Northern Link Road Tunnel Project

## **Application for Project Change**

October 2010

Figure 2-4: Changed Project Vertical Alignment

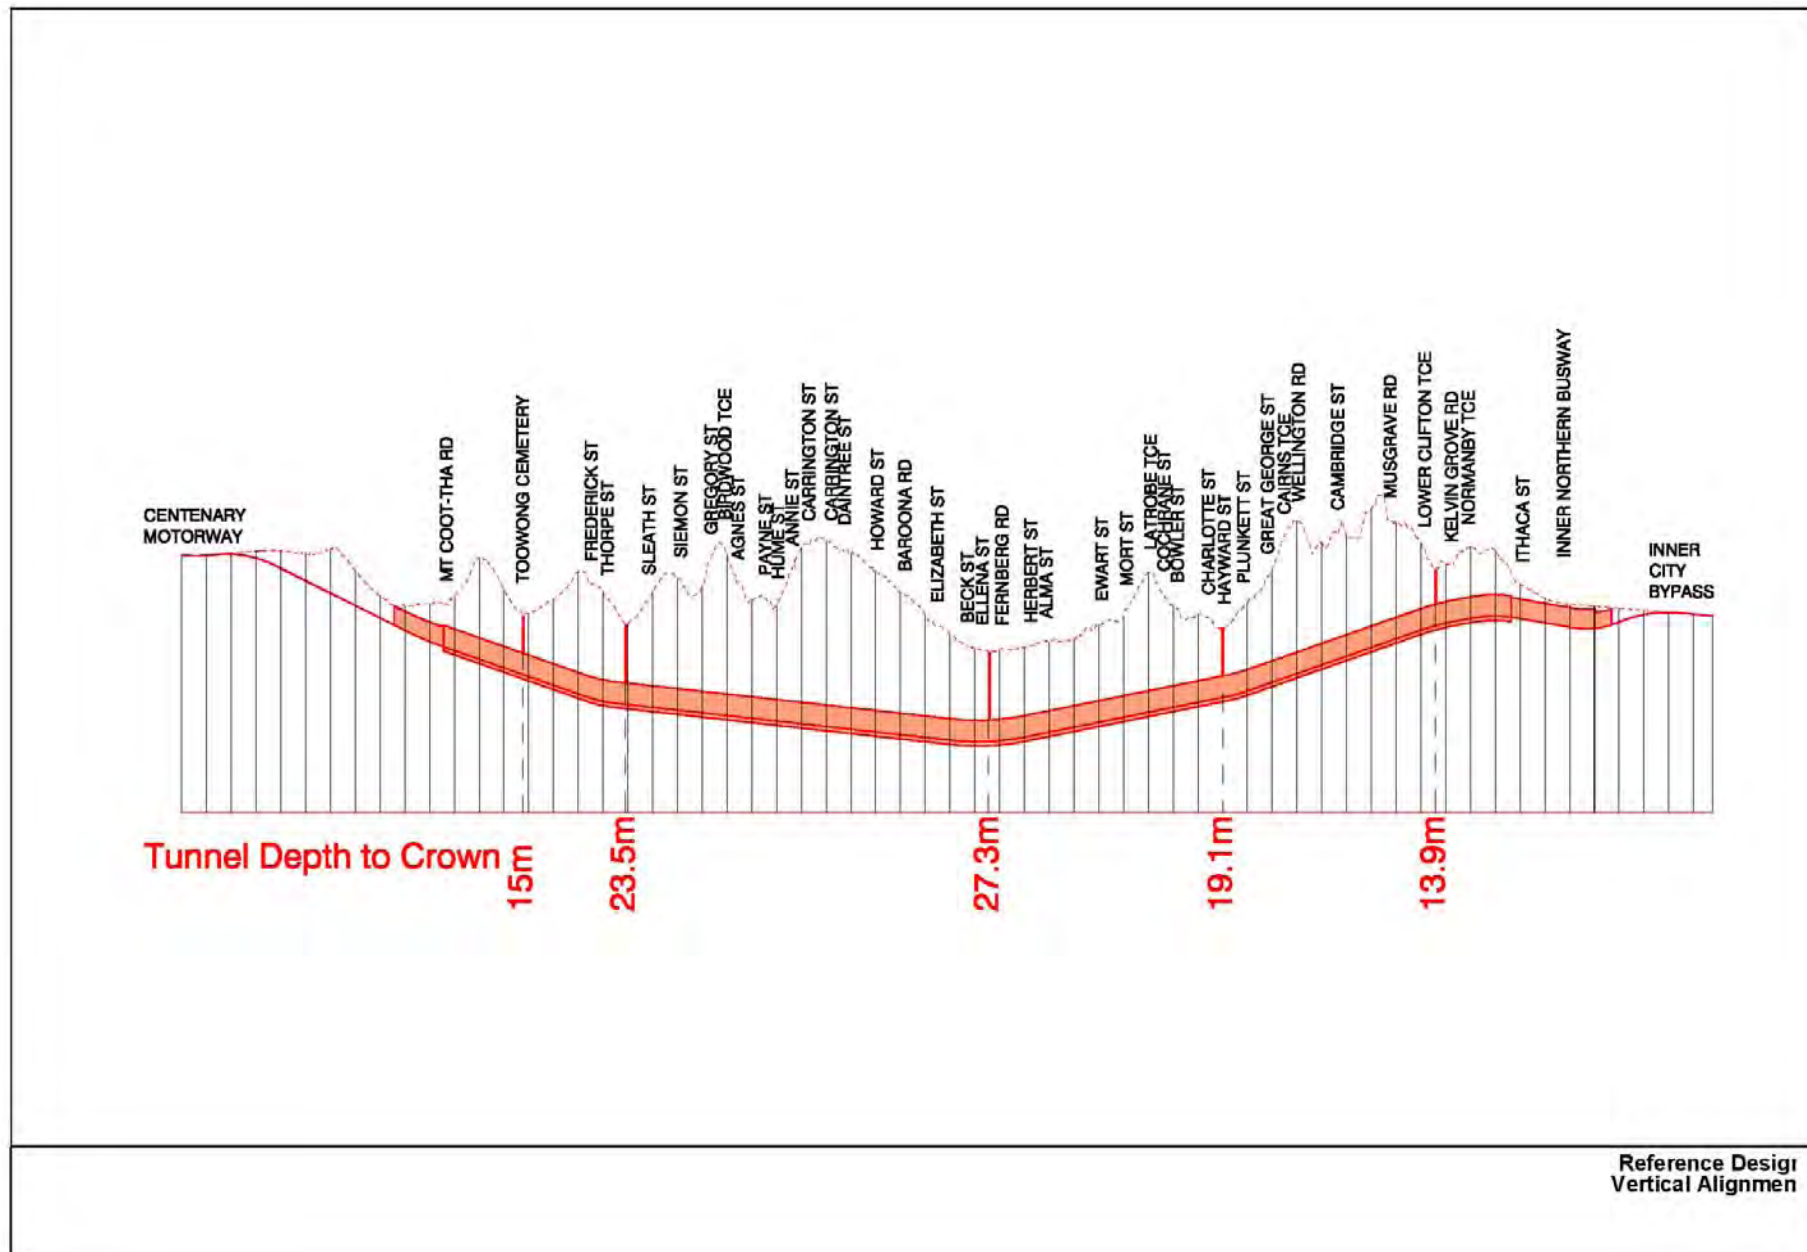
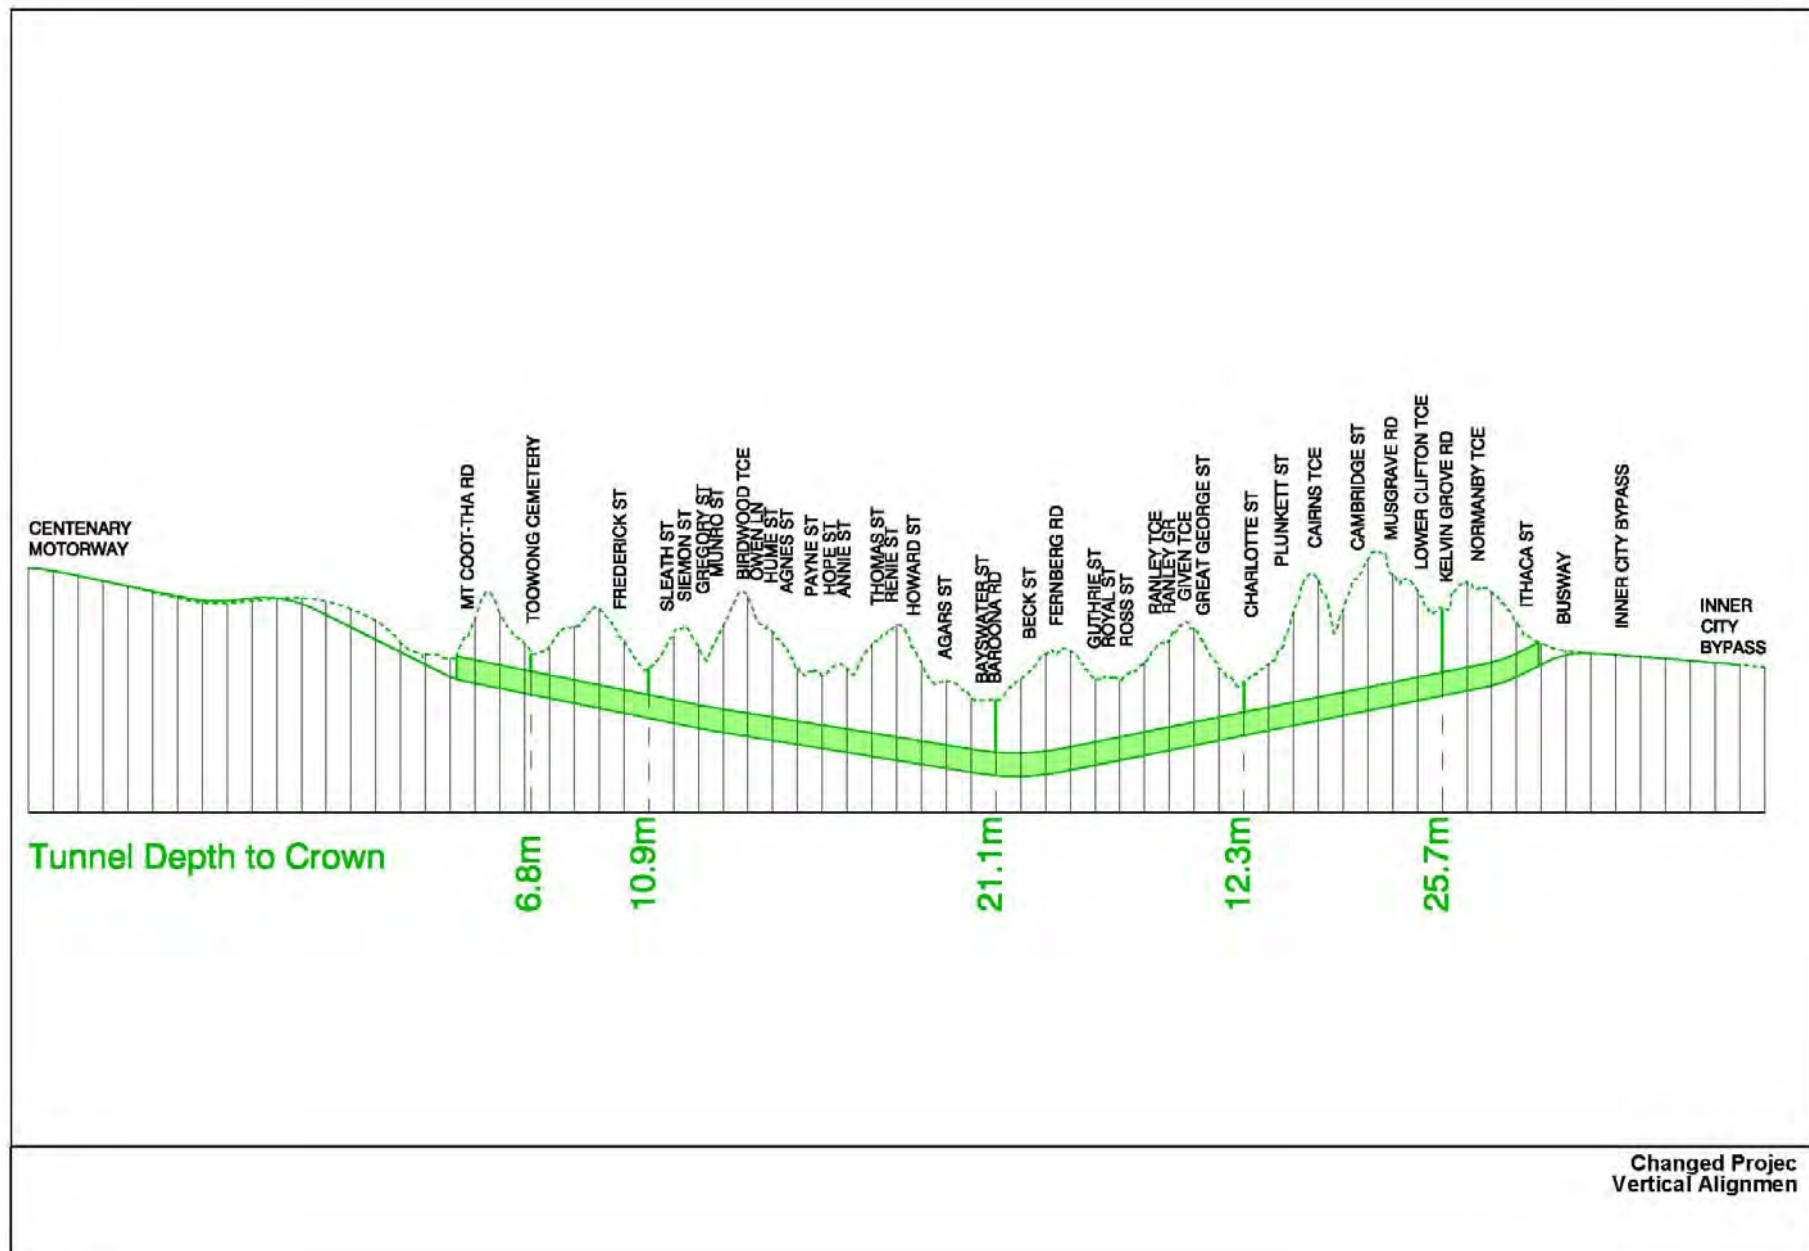
- Vertical Alignment - The vertical alignment of the main alignment for the Changed Project would be shallower for most of the route apart from the section from Carins Terrace east. This is due to the change in the horizontal alignment and ground surface levels at those locations and design changes to optimise tunnel gradients;

Design Element	Description of the Reference Design (RD)	Description of the proposed Change	Reason(s) for Change
	and 66m  Refer to <b>Figure 2-3</b> above and Supplementary Report Volume 2 Longitudinal sections	varies between approximately 10-50m and would be generally shallower than the Reference Design, although the section between Cairns Terrace and the ICB would be deeper.  Refer <b>Figure 2-4</b> and <b>Figure 2-21</b> to <b>Figure 2-28</b> .	Also due to design changes to optimise tunnel gradients.
Volumetric Title Requirements	374 parcels of land identified as affected in Supplementary EIS.  Refer to Section 3.3.2 of the Supplementary Report.	334 property holdings are affected by the Changed Project. Some 269 of these are newly affected (including 6 Council owned parcels) and 65 of these continue to remain affected as identified in the Reference Design. There may be some minor changes to these numbers as a result of detailed design and survey.	Newly identified properties are required due to the revised horizontal alignment design and further design development of tunnel infrastructure including volumetric buffer requirements (1.5m surrounding the underground structures) as well as the concept design for cross passages and underground sub-stations.

Figure 2-6: Changed Project Western Connection – Tunnel Portals

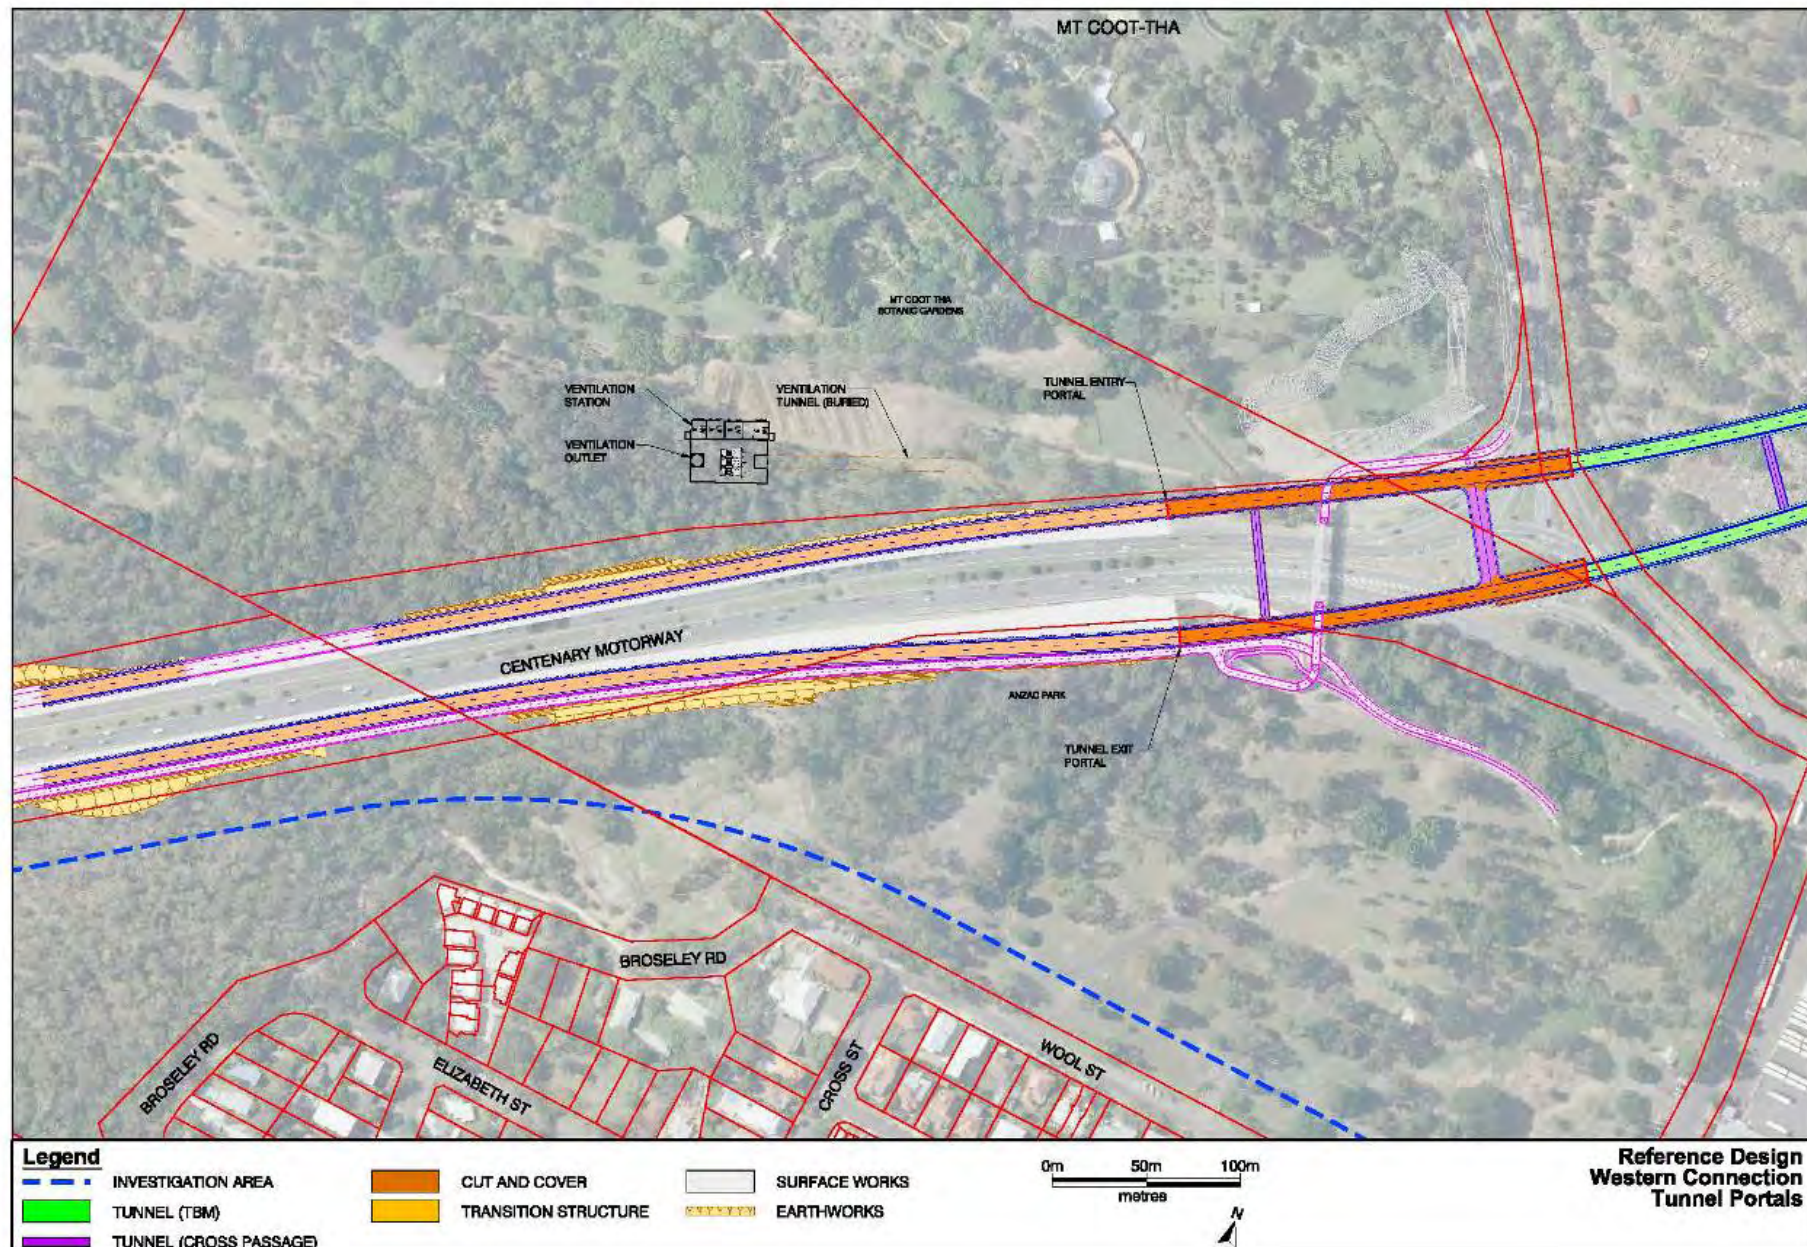
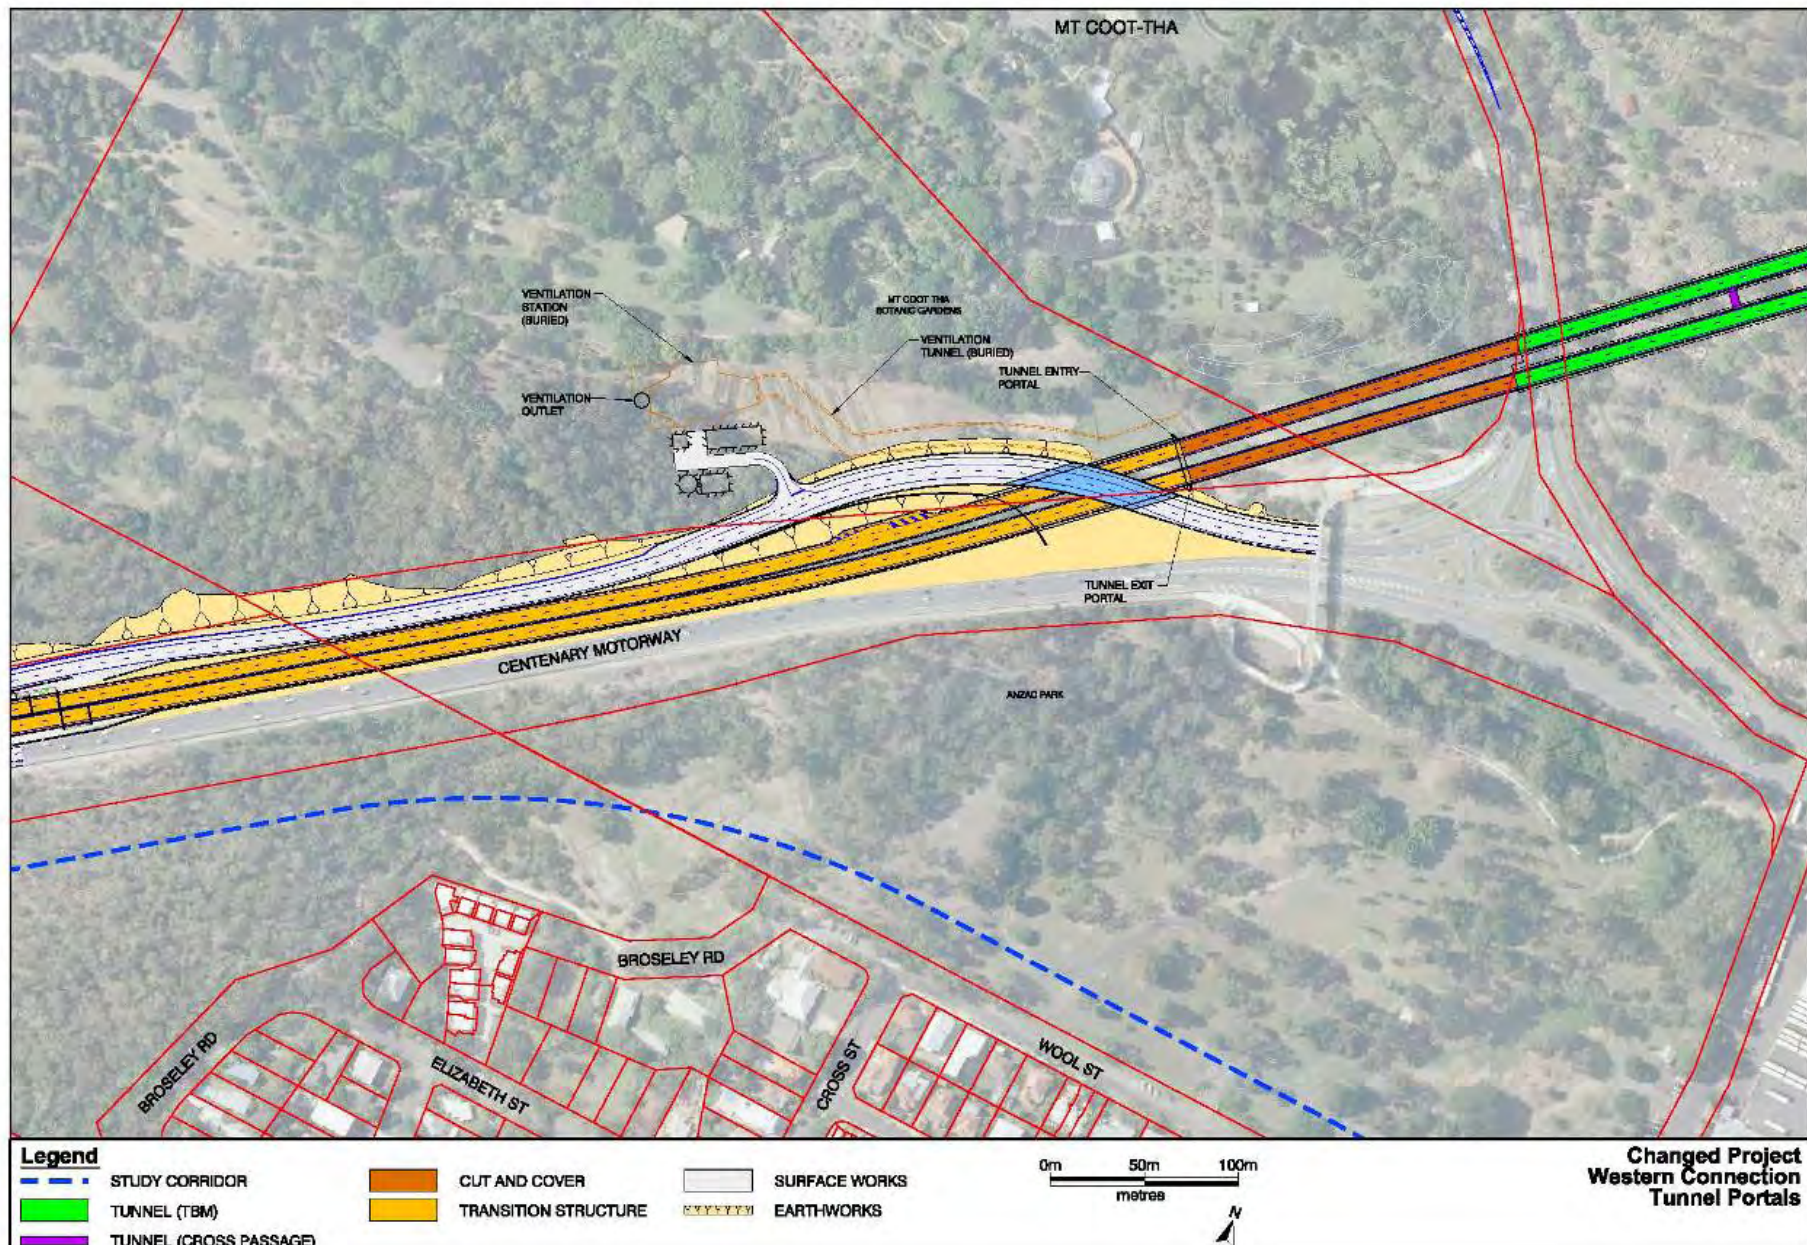
<b>Western Surface Connections</b>			
TBM portal locations	The TBM portals are separated some 50m apart, with the northern entry portal located at the corner of Mt Coot-tha Road and the roundabout adjacent to the Toowong Cemetery and the southern exit portal located in line with the middle of the roundabout adjacent to the cemetery.  Refer to <b>Figure 2-5</b> and Supplementary Report Volume 2 Planning Layouts <sup>1</sup>	The TBM portals are located together some 60m north of the northern Reference Design portal and some 100m north of the southern Reference Design portal on the western side of Mt Coot-tha Road within the western worksite  Refer to <b>Figure 2-6</b> and <b>Figure 2-31</b>	Enables both TBMs to be launched off-line within the construction worksite and outside of existing traffic, avoiding construction through Mt Coot-tha Road and the roundabout.  Provides improved grades for the associated cut and cover and transition structures to the Centenary Motorway.  Provides for the tunnel cut and cover portals to be together consolidating the construction area and also simplifying construction traffic management

Realignment of the Centenary Motorway inbound lanes to the north	<p>No design changes to the inbound lanes of the Centenary Motorway.</p> <p>Refer to <b>Figure 2-5</b> and Supplementary Report Volume 2 Planning Layouts<sup>1</sup></p>	<p>The inbound lanes of the Centenary Motorway would be realigned to the north. The inbound lanes, including the earthwork for the future widening would be constructed off-line followed by a single switch of traffic onto the new lanes.</p> <p>Refer to <b>Figure 2-6</b> and <b>Figure 2-17</b></p>	<p>To provide a single construction area and space for the centre connection of the Northern Link within the median of the Centenary Motorway.</p>
Centenary Motorway merge and diverge	<p>The Reference Design provides for a merge from the tunnel to the Centenary motorway of approximately 800m and for a diverge from</p>	<p>The Changed Project provides for a merge from the Mt Coot-tha roundabout traffic to the exit traffic from the tunnel onto the Centenary</p>	<p>The shorter merge (150m) is due to the commencement of the merge being further west than the Reference Design due to the difference in</p>
